Access Compliance Report Public Rights-of-Way (Curb Ramps)

Main Street: HARP_CT Cross Street: MANNING_DR Location: NE

ADA ID: RPAT211004142136 Ramp Type: Type 6 - Directional 1 Initial Pass/Fail: Pass Overall Compliance: No Severity Score: 5

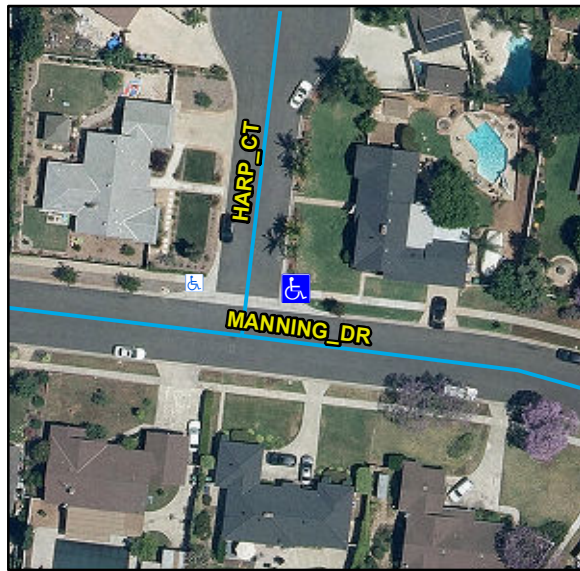
Marked Crosswalk 1 Width (in)	N/A			
N/A	Ramp Inside Crosswalk 1	N/A			
	Crossing 1 Slope (%)	6.2			
	Crossing 1 Cross Slope (%)	1.9			
Yes	Gutter Ponding	No	No	Curb Slope	11.3
Yes	Gutter Lip Height (in)	0		Road Run Slope (%)	2.8
No	Gutter Run Slope (%)	10.4		Road Cross Slope (%)	6.2
Yes	Gutter Cross Slope (%)	1.3		Parallel Ramp Side	N/A
Yes	Overall Surface Condition	Acceptable	Yes	Perp Joint Present	Yes
	Cross Gutter Present?	Yes		Spandrel Present?	Yes
	Replace Cross Gutter?	No		Replace Spandrel?	No

Remove & Replace Curb Slope. Remove & Replace Gutter.

R304.2.2, R304.5.4, STD 1115
